Airworthiness Directive

Amendment 39-4222; AD 81-11-02 R1

Airworthiness Directives; Piper Model PA-28R-200, PA-28R-201 and PA-28RT-201 Airplanes

FIGURE 1

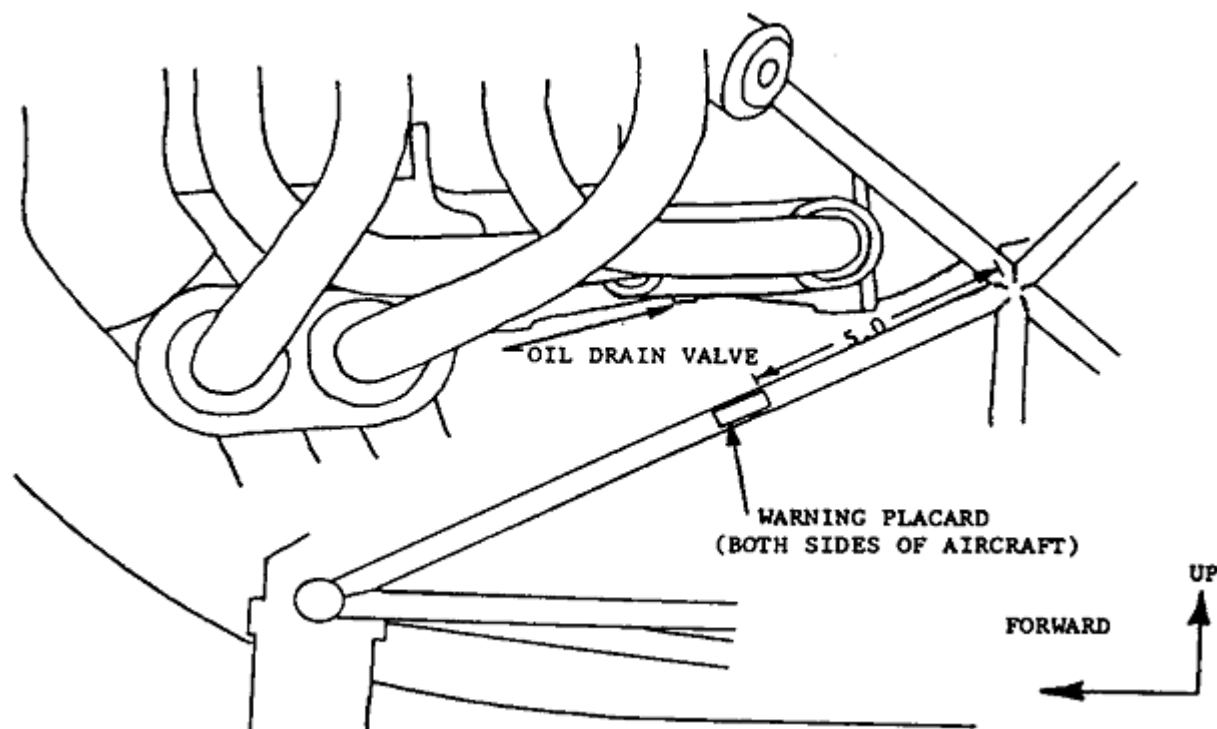
(a) Install two warning placards, one on each side, on the lower engine mount beneath the intake and exhaust tubes, in accordance with Figure 1. Use Piper

Part No. 87369-26V which reads:

"CAUTION

Unapproved Oil Drain Valves Can Cause Inadvertent Draining When the Gear is Retracted - Use Only Piper Approved Part"

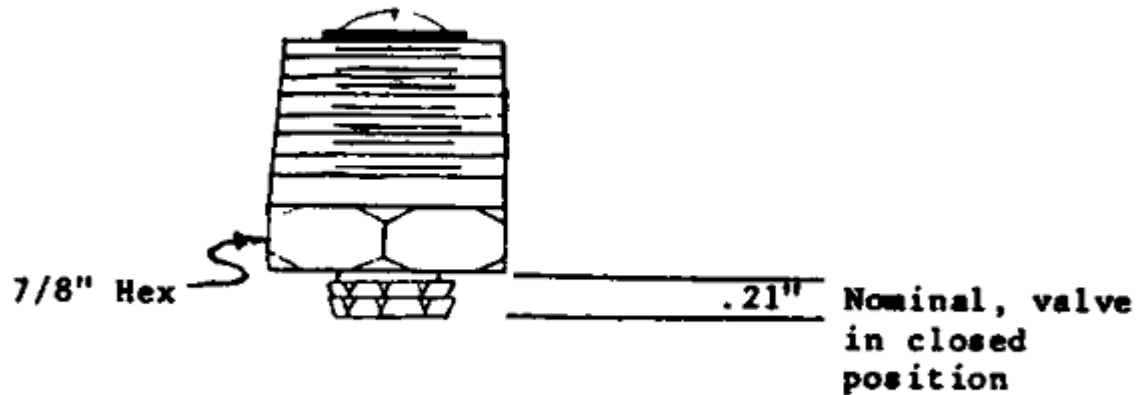
(1) Inspect the oil quick drain valve and insure that Piper Part No. 492-172V is installed and correctly safety wired. The correct valve can be identified by comparison with Figure 2. Also, the Number 1H50-1 may be visible on the hex.

(2) If an incorrect valve is installed, replace with Piper Part No. 492-172V, and safety wire, using .032 safety wire.
